LONDON ROAD, HITCHIN

Designer's Response to Stage 1 Road Safety Audit

Roundabout Modifications

Stage 1 Road Safety Audit

SCALE @ A1:	CHECKED:	APPROVED:
1:200	AFG	DDD
PROJECT NO:	DESIGNED:	DRAWN:
70056409	PG	PG
DATE:	DATE:	DATE:
July 25	July 25	July 25
DRAWING NO:	REV:	
70056409-SK-006	P03	
© WSP UK Ltd

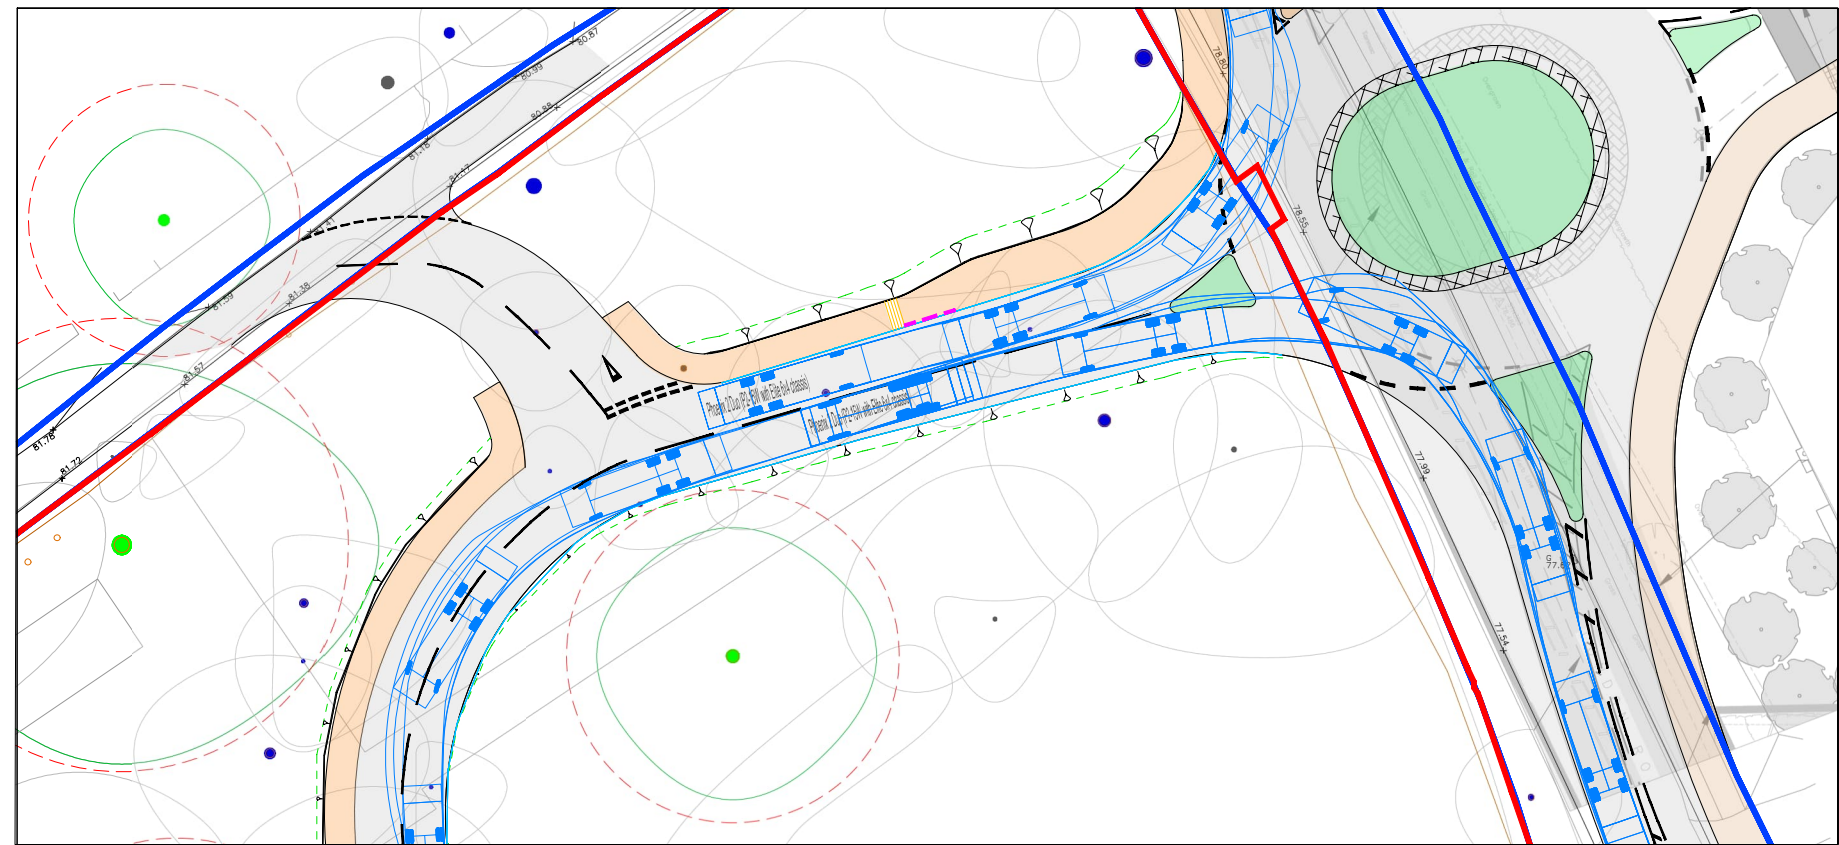
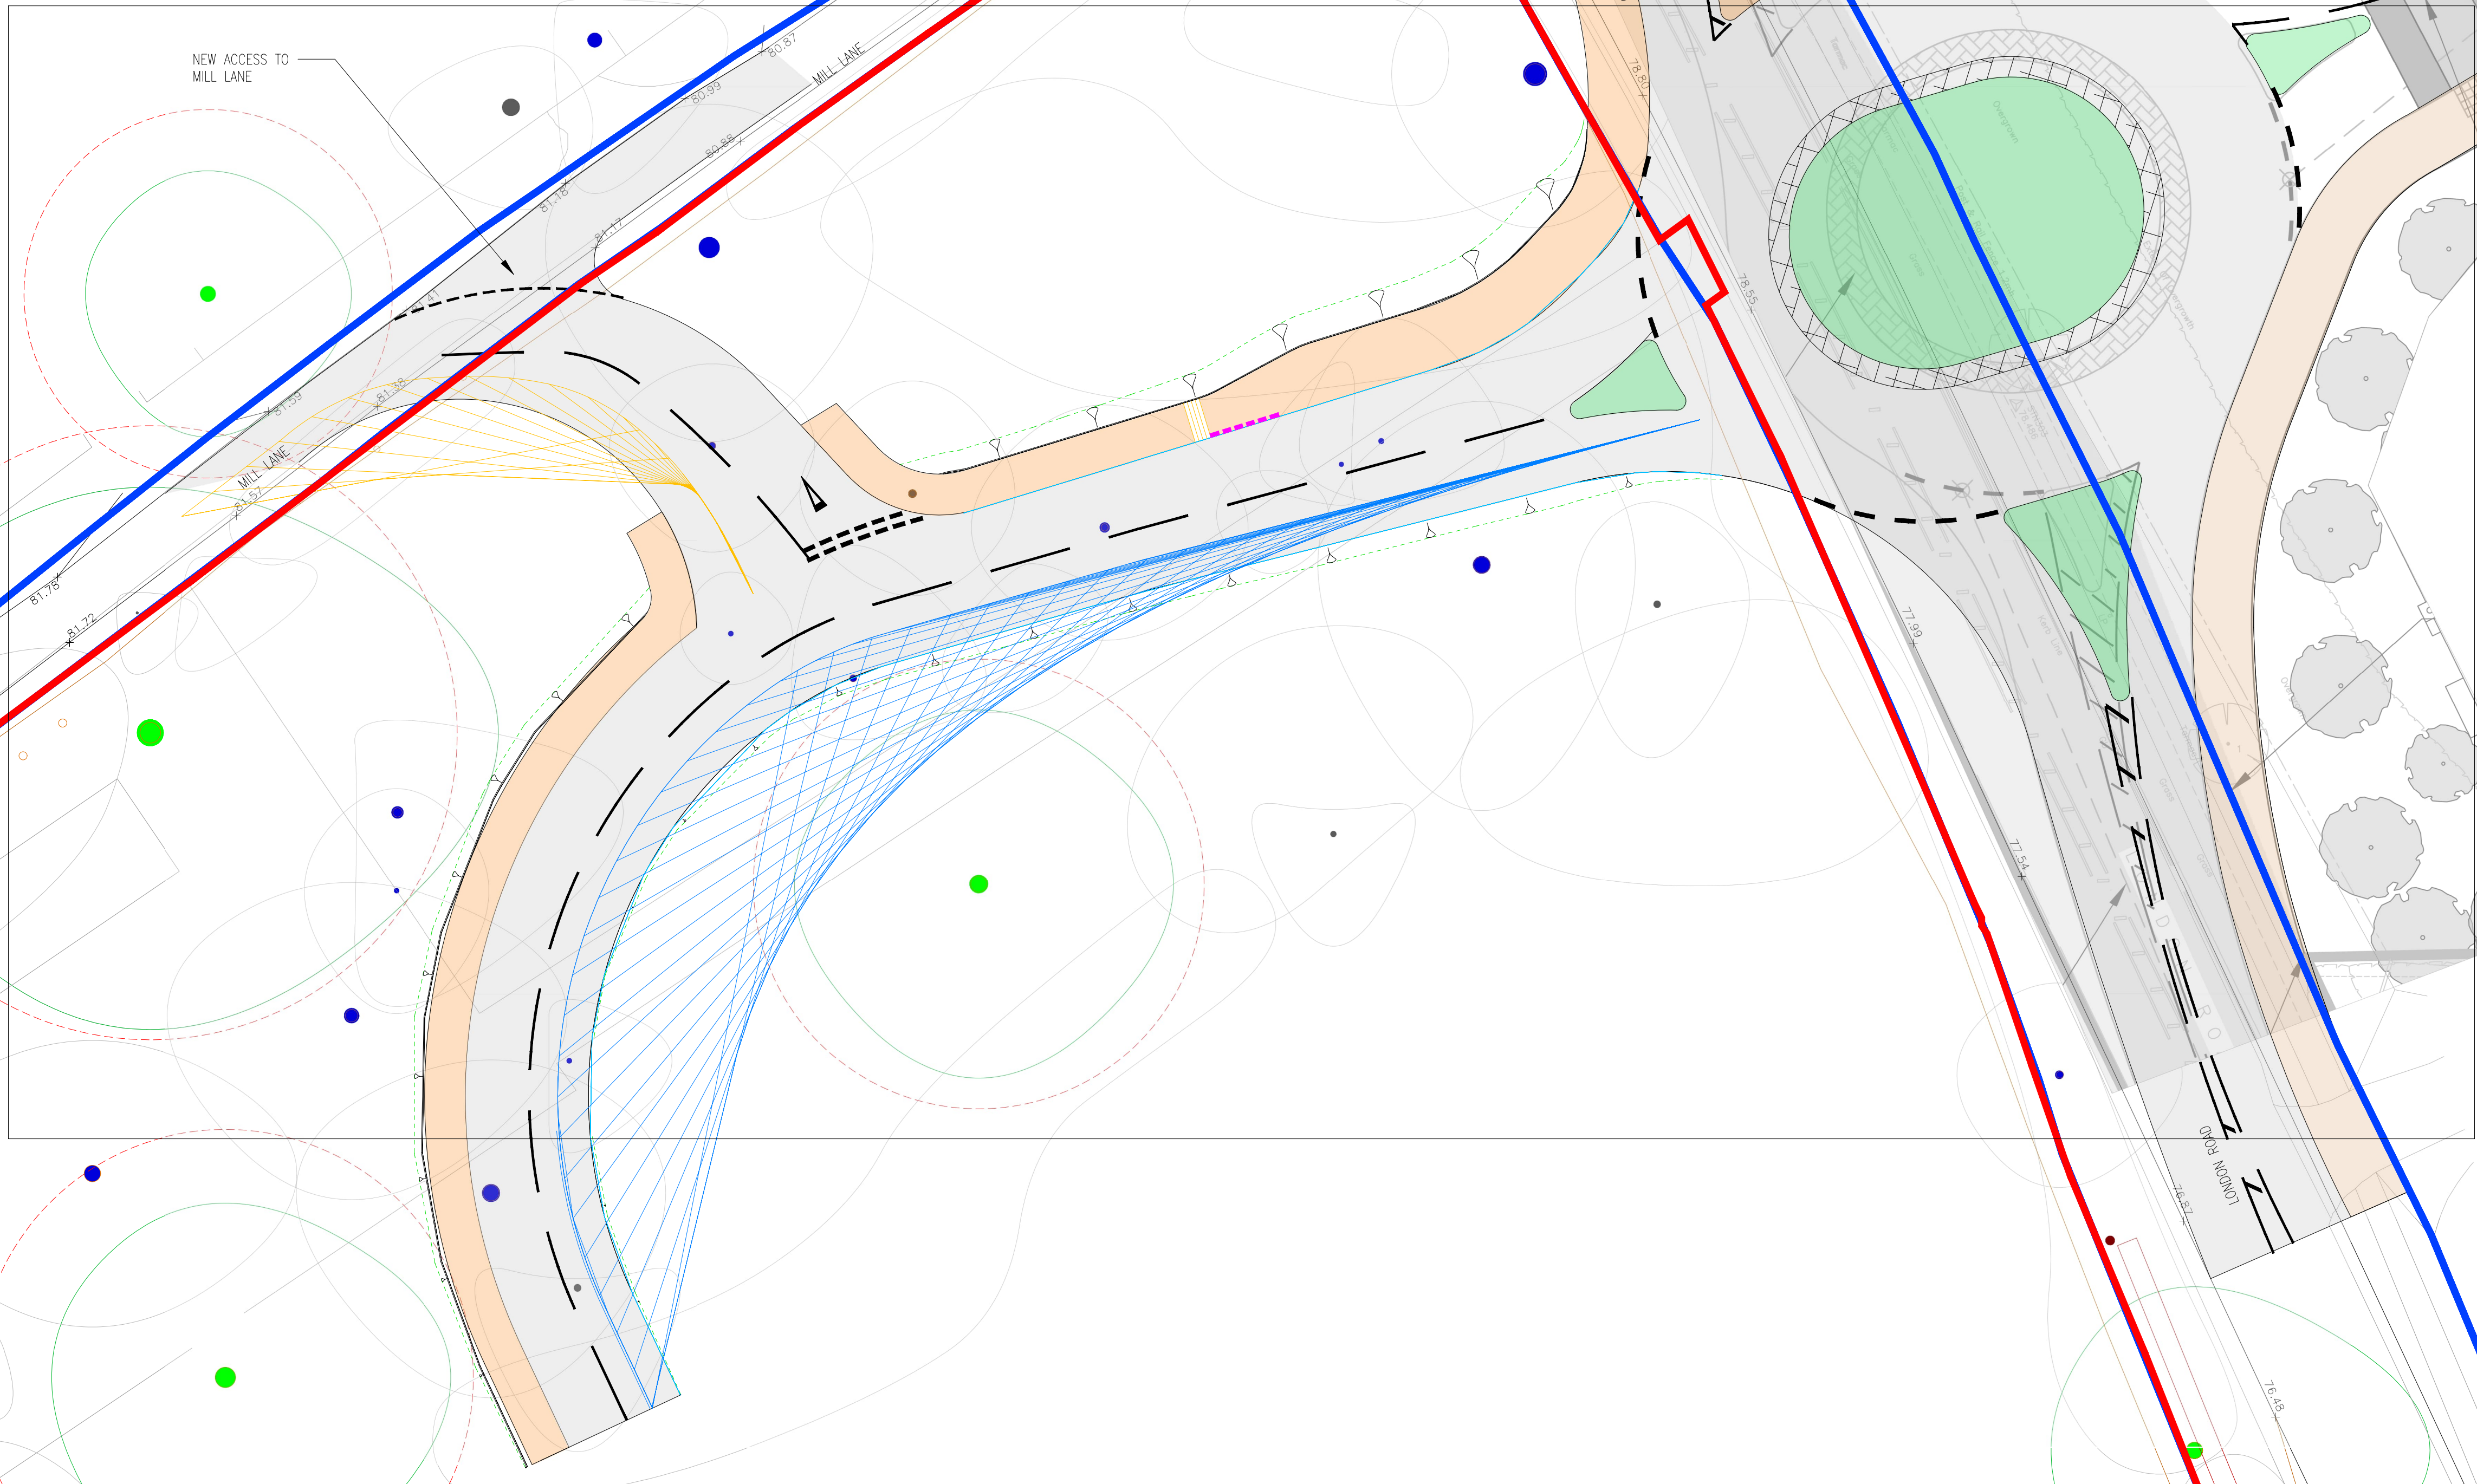
RSA Problem (2.2.1)	Location Stopped up section of Mill Lane. Summary Inadequate servicing arrangements may lead to collisions arising from difficult reversing manoeuvres. Detail It is not clear how the residential properties taking access from the stopped-up section of Mill Lane will be serviced, including for refuse collection. Inadequate provision may result in long or difficult reversing manoeuvres by service/refuse vehicles, leading to collisions with non-motorised users or other vehicles.
RSA Recommendation	Clarify servicing arrangements for the residential properties taking access from the stopped-up section of Mill Lane, and prepare vehicle swept path analysis as appropriate.
Design Organisation Response	Problem accepted. It is anticipated that given the short distances along the stopped-up section of Mill Lane, that servicing can be accommodated from either the realigned Mill Lane or from London Road. However, to maintain access should a service vehicle need to enter this closed off section, the new T-Junction crossover has been adjusted to accommodate the movement of the largest anticipated vehicle. Swept path analysis of how the refuse vehicle would access the stopped-up section of Mill Lane is shown in drawing 700564090SK-006 revision E attached to this Designer's Response in Appendix C. The tracking shows a refuse vehicle having to use both sides of Mill Lane to make the appropriate manoeuvre and in doing so an additional visibility splay have been provided to enable visibility to any oncoming vehicles.

RSA Problem (2.2.3)	Location Mill Lane junction with new road. Summary Potential collisions due to obscured junction visibility. Detail Visibility splays are not shown for Mill Lane, where it will meet the new road. Inadequate visibility between minor and major road drivers could lead to vehicle turning collisions.
RSA Recommendation	Provide suitable junction visibility splays where Mill Road meets the new road.

RSA Problem (2.2.4)	Location West and south arms of new roundabout. Summary Collisions due to large vehicles over-running traffic islands. Detail Swept path analysis indicates that larger vehicles turning left from into the new fourth arm of the roundabout appear to over-run traffic islands, which may lead to loss of control or vehicle/pedestrian collisions. The southern arm exit may also be a little narrow, although no swept path analysis has been provided for this manoeuvre.
RSA Recommendation	Swept path analysis should be rechecked and extended to the southern arm exit. If necessary, the proposed geometry should be adjusted to avoid over-running traffic islands and pedestrian/cycle areas.
Design Organisation Response	Problem accepted. The western exit has been reviewed and adjusted to accommodate the movement of the largest anticipated vehicle. The swept path analysis showing the refuse vehicle turning left into the new western arm of the roundabout has been reviewed and it has been demonstrated that the proposed layout can accommodate the movement. The revised swept path analysis is shown in WSP drawing 700564090SK-006 revision E in Appendix C. The southern exit has been reviewed and adjusted to accommodate the movement of the largest anticipated vehicle. Swept path analysis is now provided and demonstrates that the proposed layout can accommodate the movement.

RSA Problem (2.2.5)	Location Refuge island on north arm of roundabout. Summary Pedestrian trips/falls or collisions with vehicles. Detail The tactile paving rafts on the refuge island, as shown, do not align with the opposite tactile paving rafts. This could lead sight-impaired pedestrians into trips/falls, or confusion causing collisions with passing vehicles.
RSA Recommendation	Tactile paving rafts should be correctly aligned.
Design Organisation Response	Problem accepted. Tactile paving rafts are now correctly aligned.
Overseeing Organisation Response	
Agreed RSA Action

RSA Problem (2.2.6)	Location Mill Lane/new road junction. Summary Absence of pedestrian facilities may lead to trips or falls. Detail No dropped kerbs or tactile paving are shown at the proposed junction between Mill Lane and the new road. This could cause mobility or vision impaired pedestrians to trip or fall within the carriageway and potentially be struck by a moving vehicle.
RSA Recommendation	Provide dropped kerbs and tactile paving at the Mill Lane/new road junction.
Design Organisation Response	Problem accepted. Dropped kerbs and tactile paving provided at the Mill Lane/new road junction and are illustrated in drawing 700564090SK-006 revision E attached to this Designer's Response in Appendix C.
Overseeing Organisation Response	
Agreed RSA Action

It is not clear how the residential properties taking access from the stopped-up section of Mill Lane will be serviced, including for refuse collection. Inadequate provision may result in long or difficult reversing manoeuvres by service/refuse vehicles, leading to collisions with non-motorised users or other vehicles.

Visibility splays are not shown for Mill Lane, where it will meet the new road. Inadequate visibility between minor and major road drivers could lead to vehicle turning collisions.

Swept path analysis indicates that larger vehicles turning left from into the new fourth arm of the roundabout appear to over-run traffic islands, which may lead to loss of control or vehicle/pedestrian collisions. The southern arm exit may also be a little narrow, although no swept path analysis has been provided for this manoeuvre.

The tactile paving rafts on the refuge island, as shown, do not align with the opposite tactile paving rafts. This could lead sight-impaired pedestrians into trips/falls, or confusion causing collisions with passing vehicles.

No dropped kerbs or tactile paving are shown at the proposed junction between Mill Lane and the new road. This could cause mobility or vision impaired pedestrians to trip or fall within the carriageway and potentially be struck by a moving vehicle.

Design Organisation Response	Problem accepted. Junction visibility splays are now provided for where Mill Lane meets the new road and have been illustrated in drawing 700564090SK-006 revision E attached to this Designer's Response in Appendix C. The visibility splays shown are 2.4m x 43m suitable for the 30mph design speed.
Overseeing Organisation Response	
Agreed RSA Action
